Access Compliance Report Public Rights-of-Way (Curb Ramps)

Main Street: WEATHERBY_RD Cross Street: ST_ALBANS_DR Location: SW

ADA ID: RPRK211217134125 Ramp Type: Type 4 - Parallel Initial Pass/Fail: Fail Overall Compliance: No Severity Score: 2

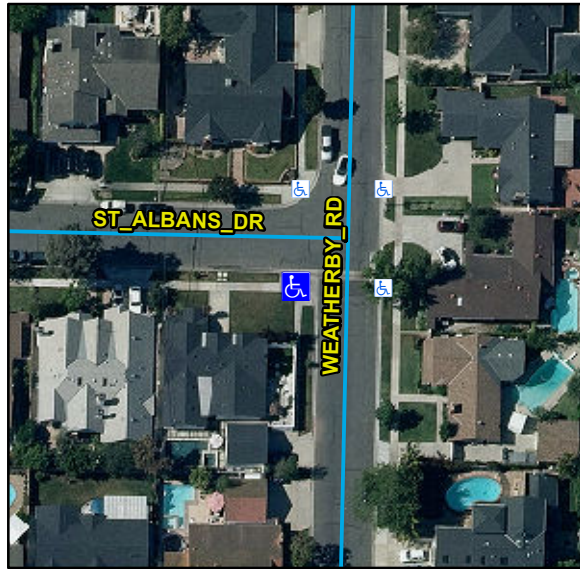
Compliance	Description	Data	Compliance	Description	Data
N/A	Ramp Length LT (in)	91	N/A	Ramp Length RT (in)	93
Yes	Ramp Width LT (in)	102	Yes	Ramp Width RT (in)	102
Yes	Ramp Run Slope LT (%)	7.5	Yes	Ramp Run Slope RT (%)	5.6
Yes	Ramp Cross Slope LT (%)	1.3	No	Ramp Cross Slope RT (%)	2.5
N/A	Landing Present	N/A	N/A	DWS Provided	N/A
N/A	Landing Length (in)	N/A	N/A	DWS Contrast	N/A
N/A	Landing Width (in)	N/A	N/A	DWS Length (in)	N/A
N/A	Landing Run Slope (%)	N/A	N/A	DWS Full Width	N/A
N/A	Landing Cross Slope (%)	N/A		DWS Offset Type	N/A
N/A	Landing Movement Obstructed?	N/A	N/A	DWS Offset Left (in)	N/A
	Landing Movement Type	N/A	N/A	DWS Offset Right (in)	N/A
N/A	Landing Shared	N/A			
N/A	Clear Space	Yes			
N/A	Clear Space To Crosswalk (in)	N/A			
N/A	Marked Crosswalk 1	No	N/A	Marked Crosswalk 2	No
	Crossing 1 Direction	E		Crossing 2 Direction	N
	Marked Crosswalk 1 Width (in)	N/A		Marked Crosswalk 2 Width (in)	N/A

Remove & Replace Curb Ramp With Two New Directional Ramps or Equivalent.
